4.I. Staff Review - 777 Stevens Avenue - Park Danforth

**LEGAL ADVERTISEMENT
PORTLAND PLANNING BOARD MEETING**

**AGENDA
PORTLAND PLANNING BOARD**

Planning and Urban Development Department

L3.2

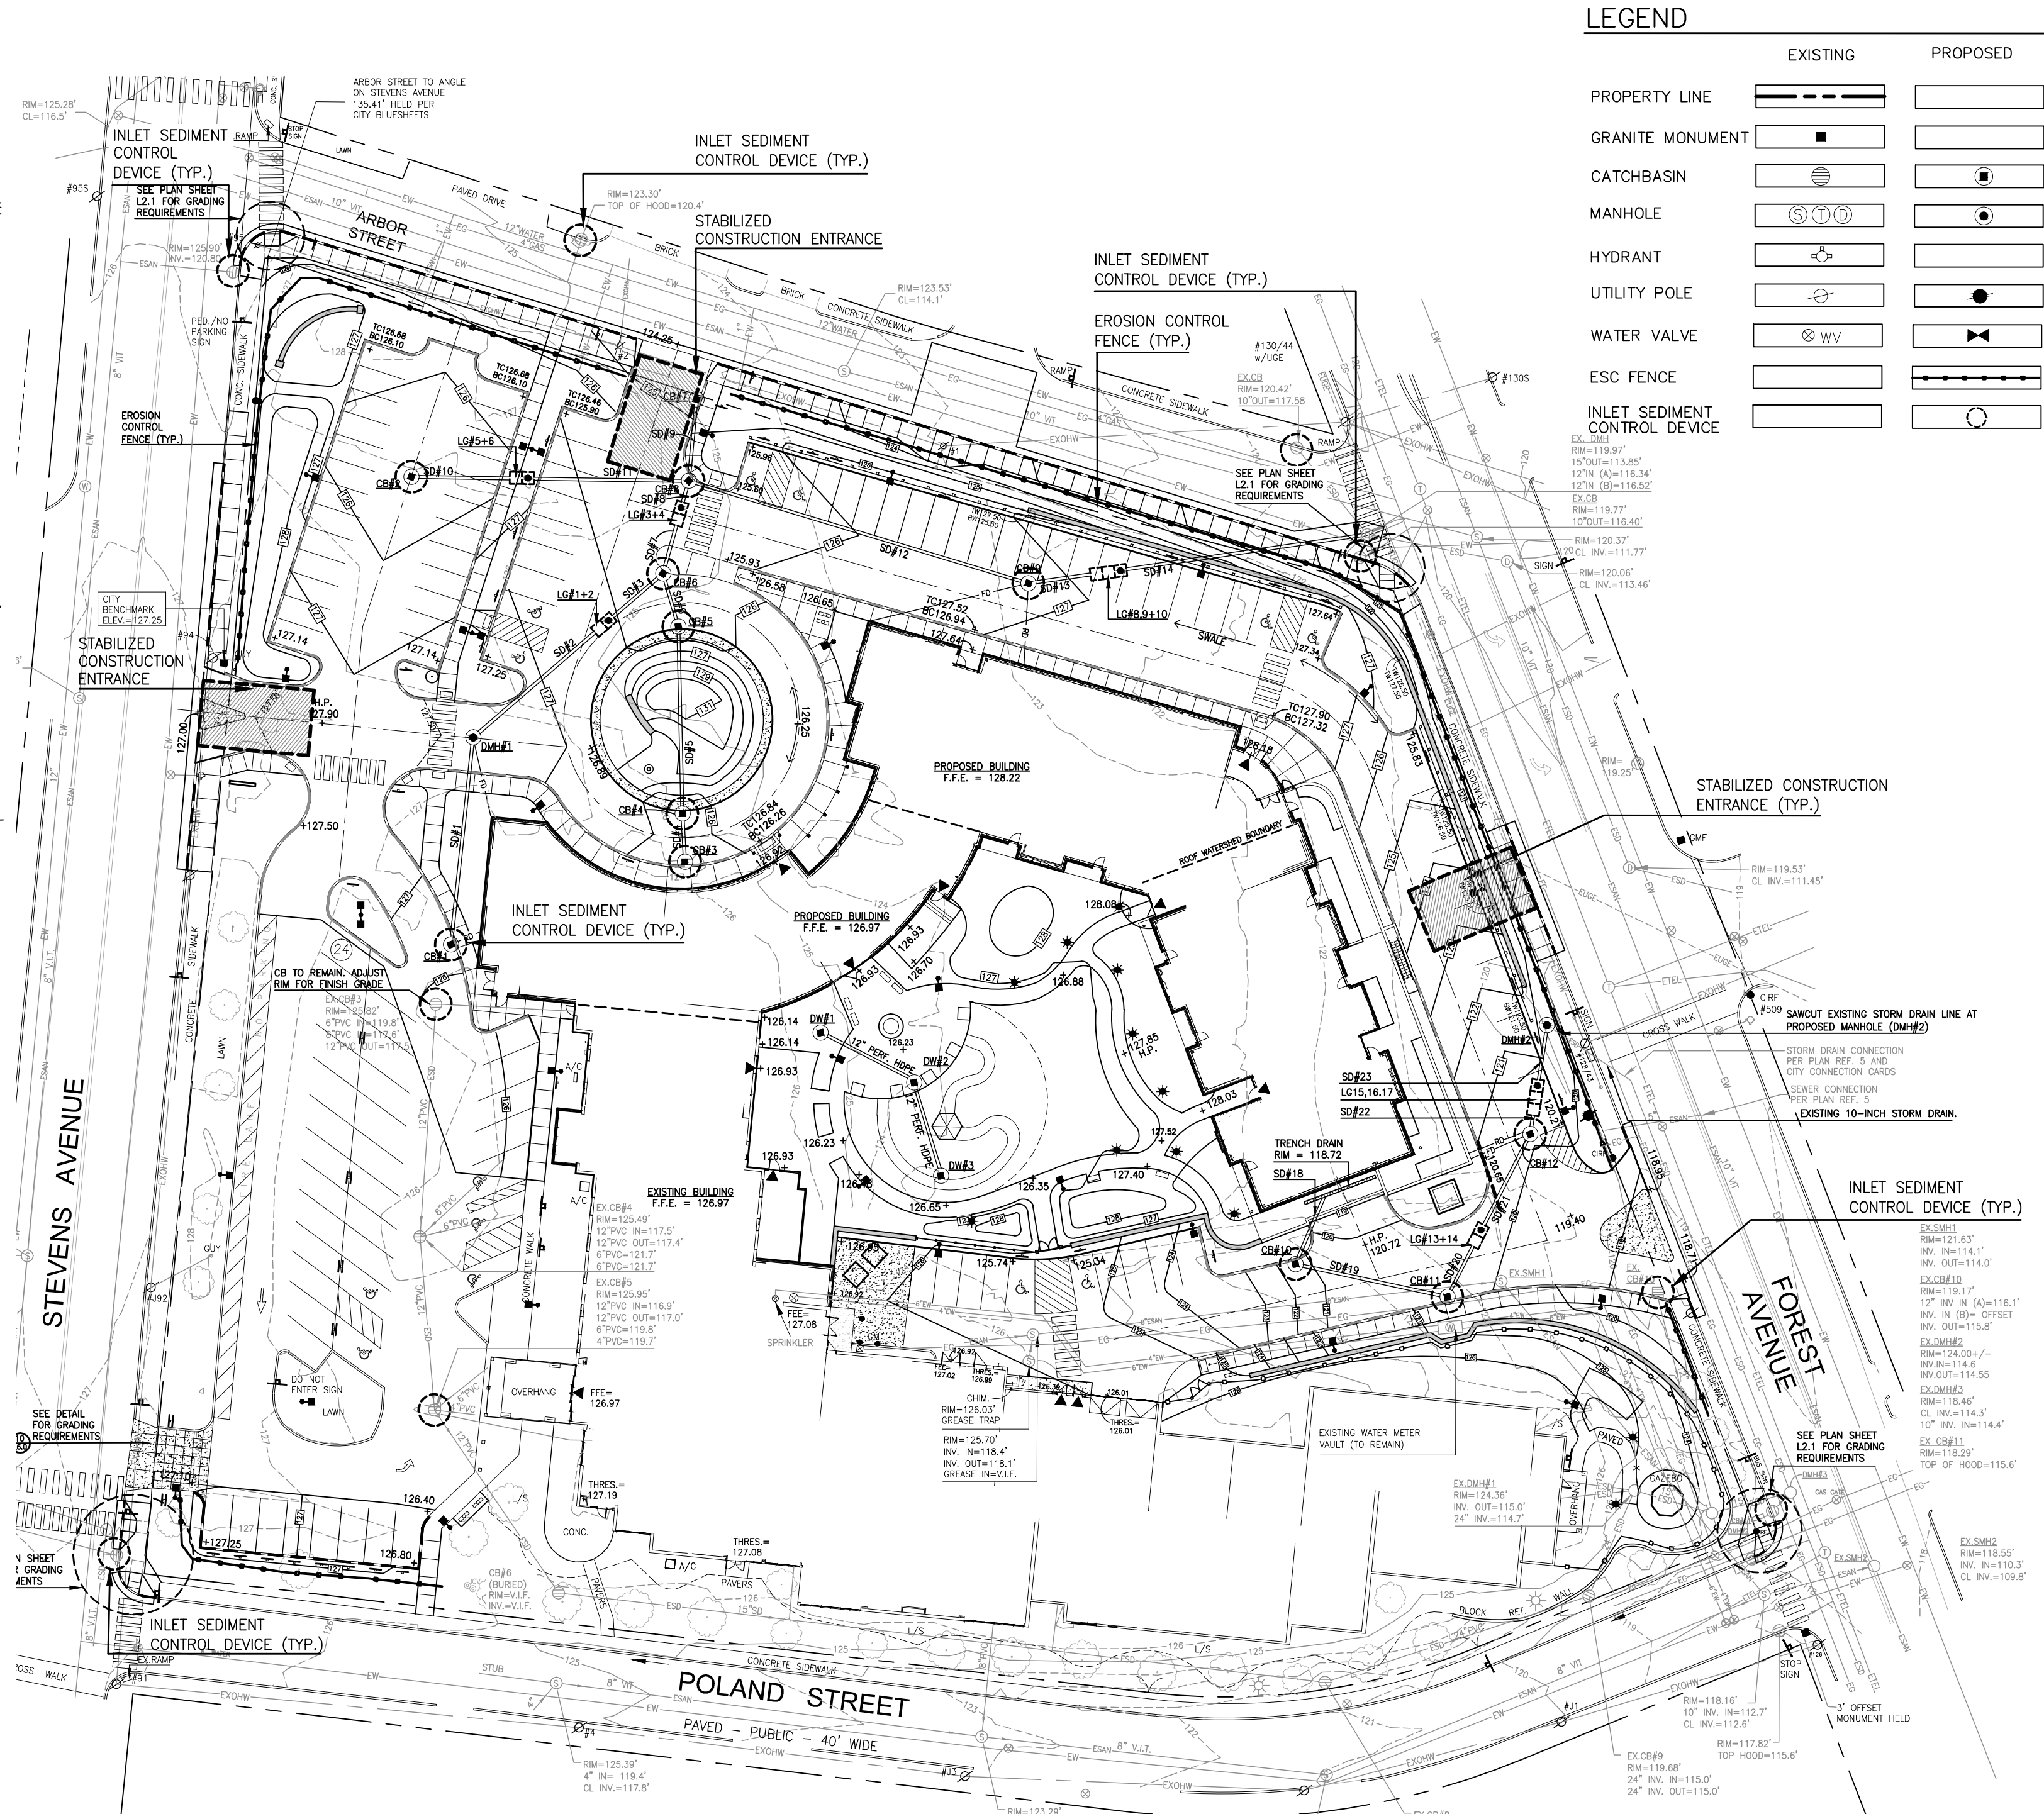
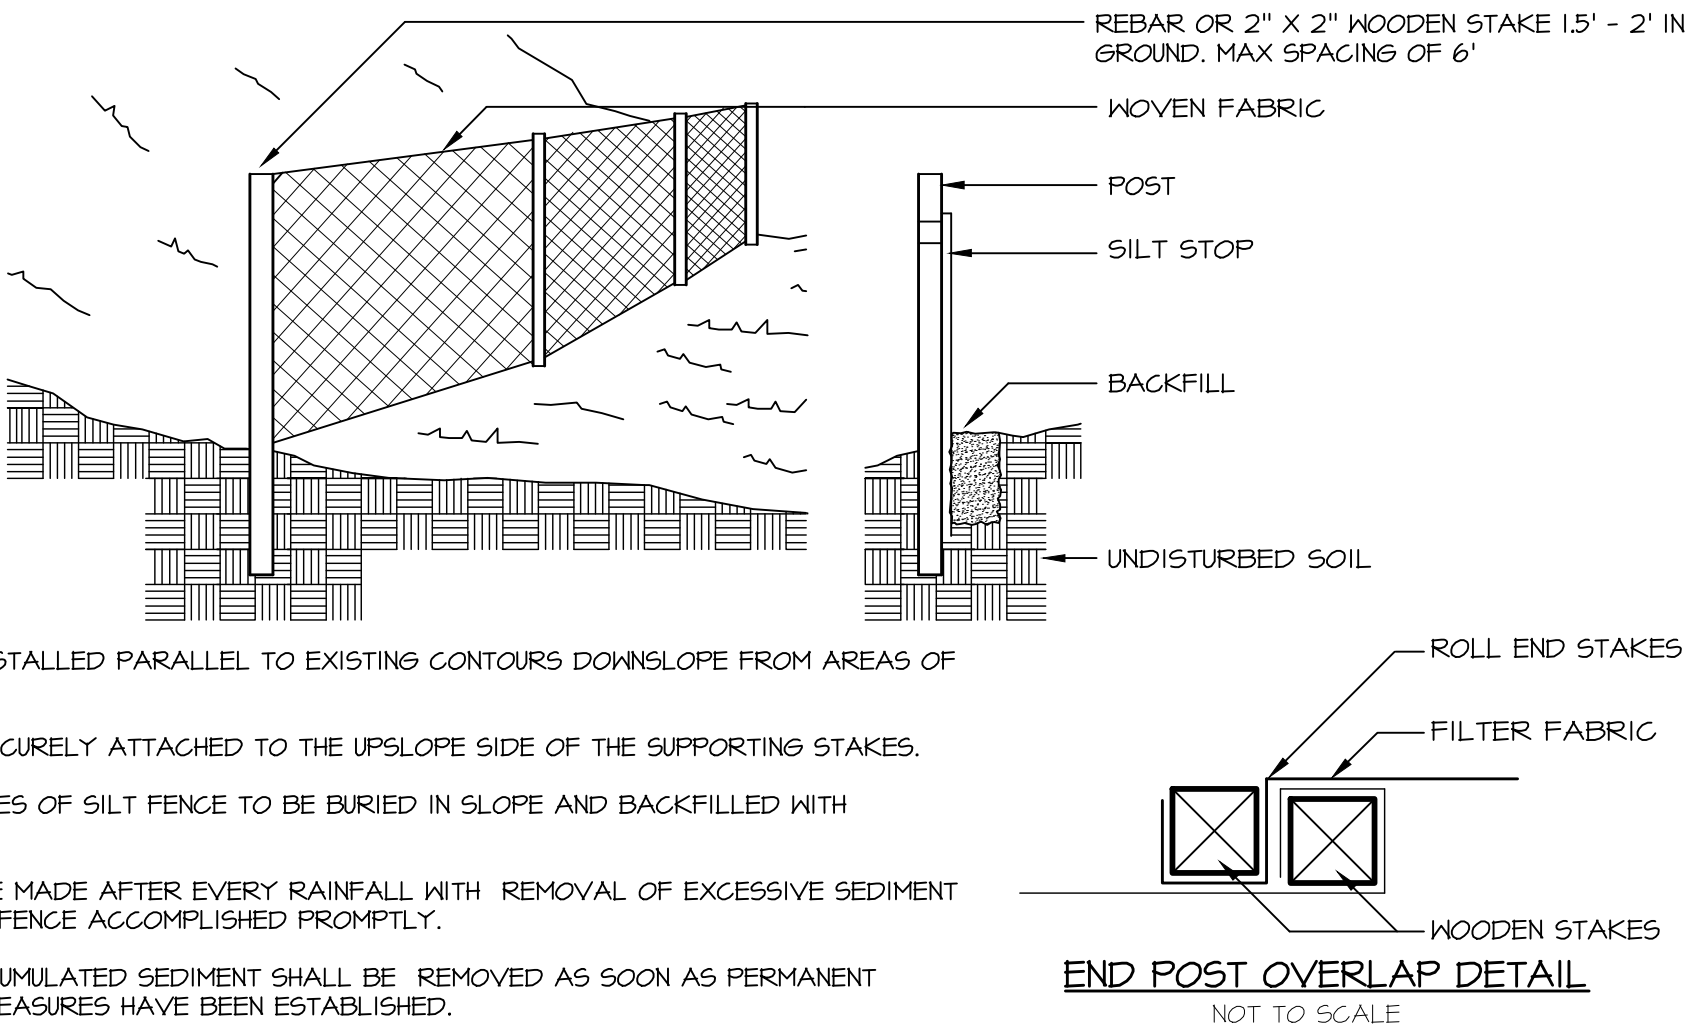
- 1) The Erosion and Sediment Control Plan (L3.2) should identify an inlet sediment control device on existing CB# 4.

i) The Erosion and Sediment Control Plan (L3.2) should identify a stabilized construction entrance at each location where trucks/equipment may enter or exit the site; this should be coordinated with the entrances noted on the Construction Management Plan (L1.1)

ii) The Erosion and Sediment Control Plan (L3.2) should identify additional inlet sediment control devices on existing catch basins that are adjacent to the construction on the south side and east side of the site, specifically CB's 3,4,5, 10.

- **The Erosion and Sediment Control Plan has been revised to correspond with the Construction Management Plan (L1.1)**

Title: SITE DETAILS

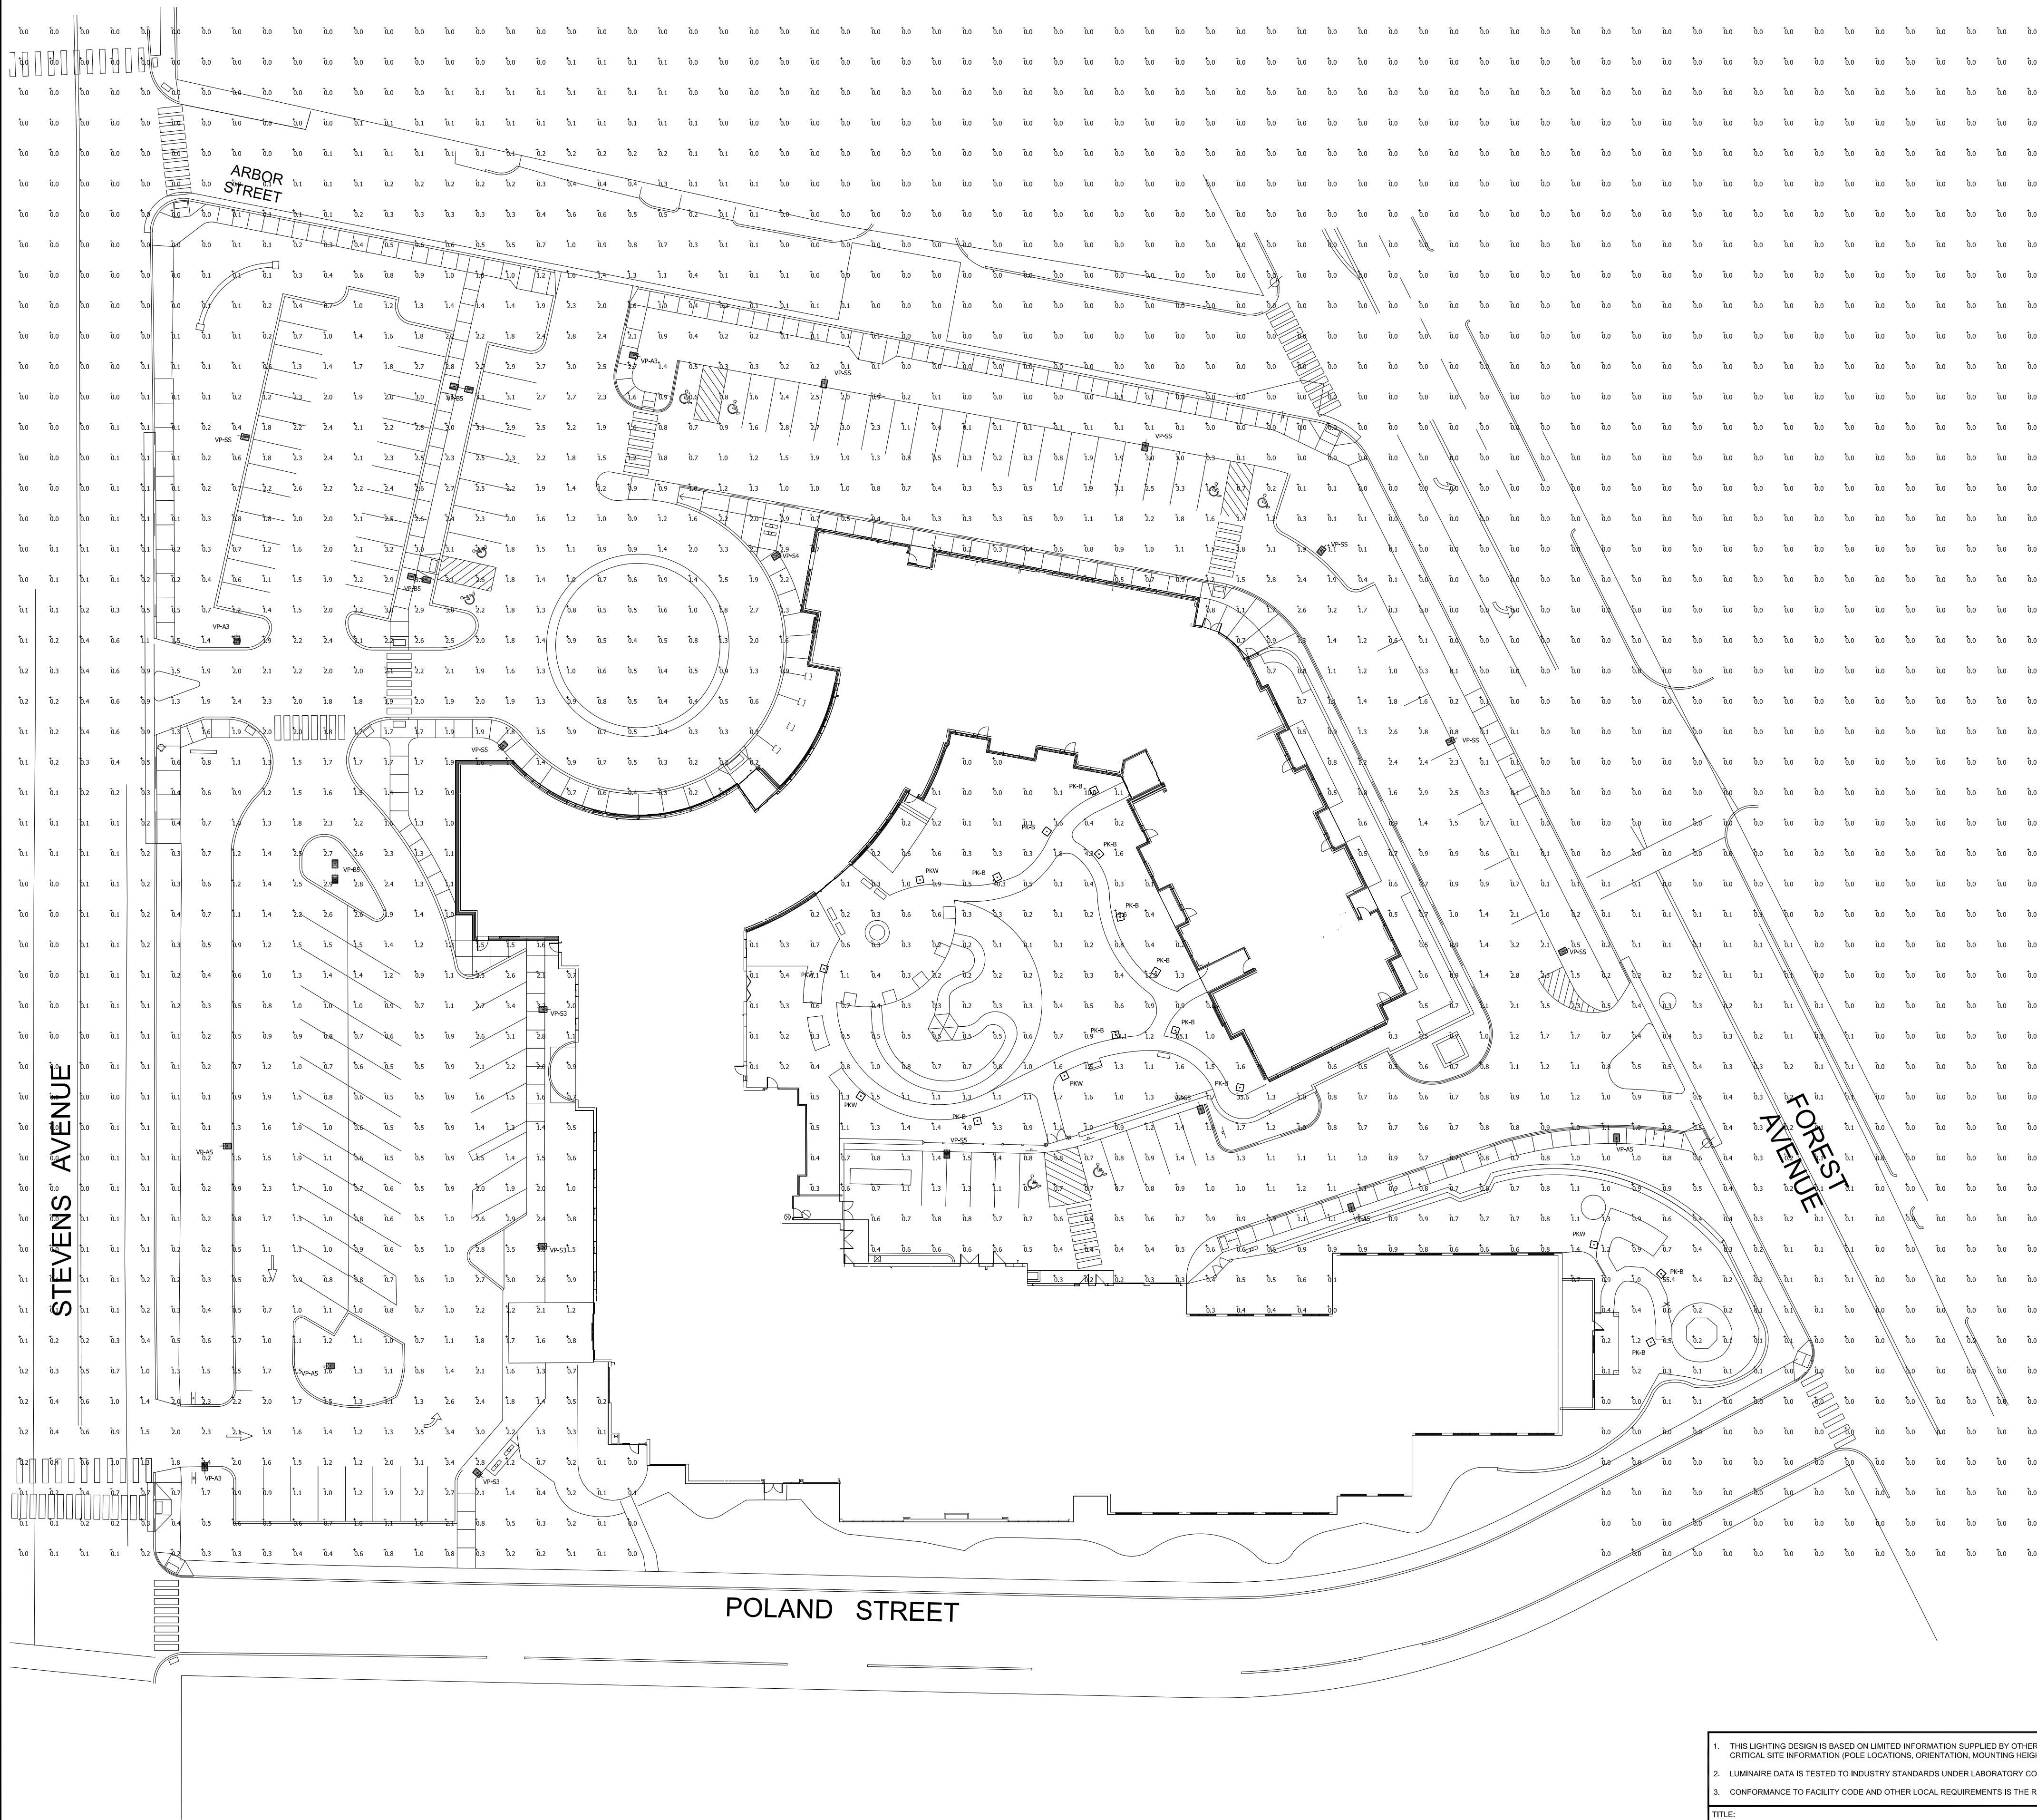
- 2) Sheet L6.2 –The Snout detail contains a remnant note stating that “The Snout shall be provided on Proposed Catch Basins #6100, #6101 and #6102”; this note should be deleted.
- 3) All previous review comments have been adequately addressed.

4) Sheet L6.2- The Site Details plan included a Snout for installation on "garage" drainage structures. Because the site catch basins will essentially provide "pre-

- **Detail plan sheet L6.2 has been revised accordingly**
